U2001A-03

S E R V I C E N O T E

U2001A 10MHz – 6GHz USB Sensor

Difficulty to attach USB power sensor cable to power sensor unit.

Figure 1: USB power sensor cable fully attached to power sensor unit

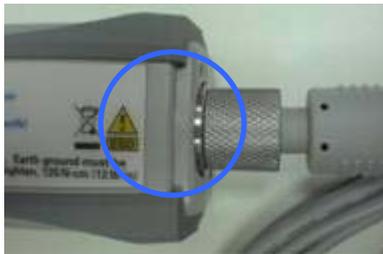
When the USB power sensor cable is attached to the power sensor unit, user may find it difficult to attach the cable to the power sensor unit.

- 1) If user have not used the cable (new unit), kindly contact Agilent for free of charge part replacement.
- 2) If user face difficulty to attach the cable to the power sensor unit, kindly contact Agilent for free of charge part replacement. Kindly scrap the used cable.
